PUBLIC INTEREST REVIEW FOR GROUND WATER APPLICATIONS

SUBJECT: Application G- **17115** Supersedes review of _____
Date of Review(s)

A. GENERAL INFORMATION: Applicant's Name: **Robert & April Jossy** County: **Washington**

Ground Water Application G-17115, Jossy
Washington County, Hillsboro & Forest Grove Quads

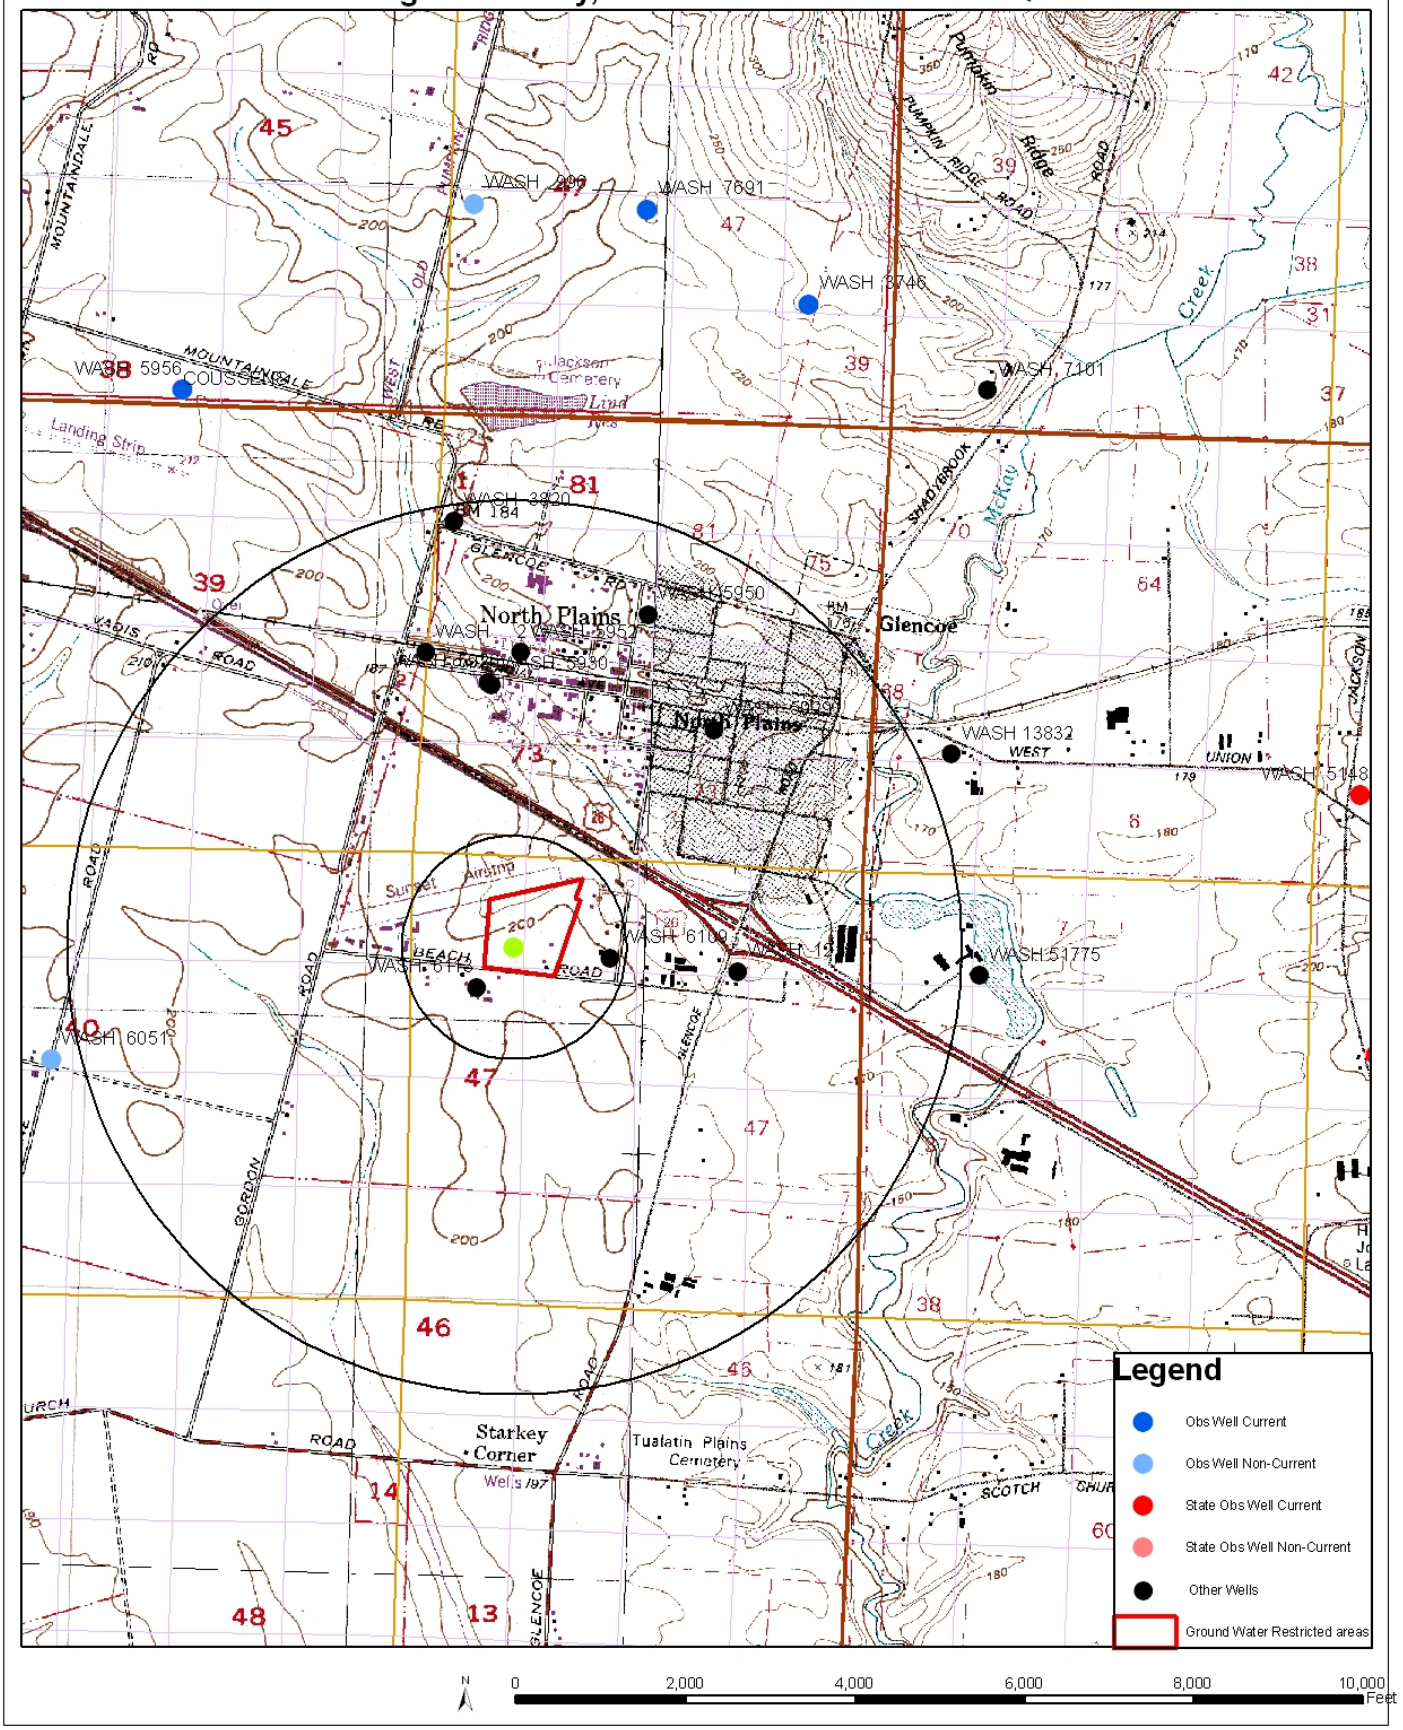
Basis for aquifer hydraulic connection evaluation: None of the streams are within ¼ mile of the well and the estimated ground water is well below the two un-named tributaries, therefore no hydraulic connection. The ground water level is close to the level of McKay Creek especially at a mile from the well, therefore, there it may be hydraulically connected.
